New VFR Charting Changes for Wind Turbines Take Effect in August

Effective on or around August 10, 2023, the FAA's Aeronautical Information Services (AIS) Visual Charting Team will begin implementing charting enhancements to Sectional Aeronautical, VFR Terminal Area Charts, and Helicopter Route Charts to more clearly depict the location of wind turbine farms. This change will also be published in the Aeronautical Chart User's Guide at [bit.ly/FAAChartGuide](https://www.faa.gov/air_traffic/flight_info/aeronautical/charting).

*A few examples of Wind Turbine Farms with enhanced depiction near Amarillo, TX.
(Dallas-Ft. Worth VFR Sectional Chart.)*

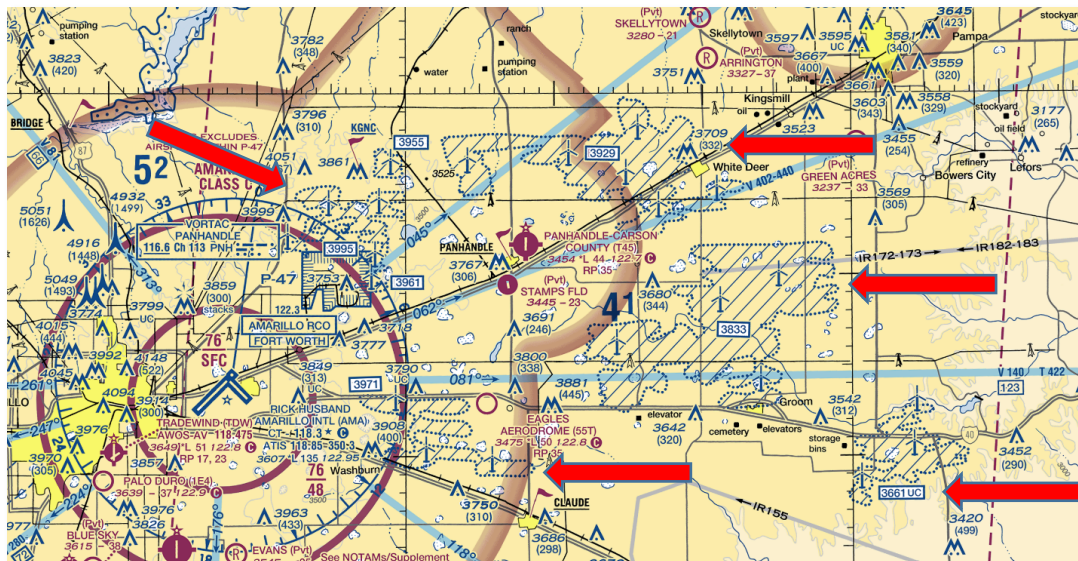
1. Replace the current dashed line border with a dotted line border (aviation blue) for easier identification of the boundaries of the wind turbine farm.
2. Add 45-degree (diagonal) cross-hatching lines within all wind turbine farms for increased conspicuity.
3. Revise the masked elevation box to include a white background and include the mean sea level (MSL) elevation figure of the highest obstruction (wind turbine rotating blade tip at the 12 o'clock position) within the wind turbine farm. The letters UC are added to depict a wind turbine farm *Under Construction*.
